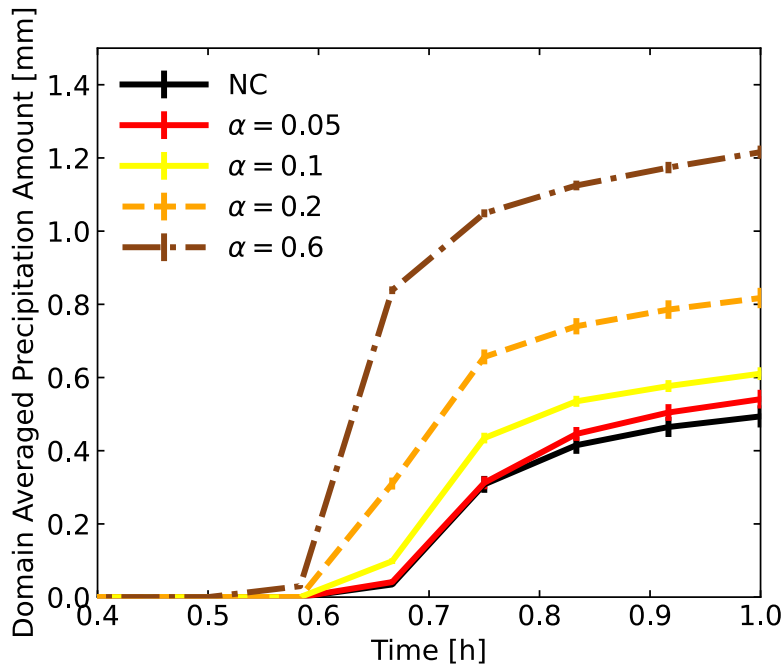
a) As already previously pointed out by the reviewer: the choice of axis ranges in Figs. 3a, 6, 7, 8 is not optimal, since the vast majority of plot area is left blank.
Thanks for your comment. We have adjusted the axis ranges in Figs. 3a, 6, 7, and 8 to utilize the plot area more effectively like:
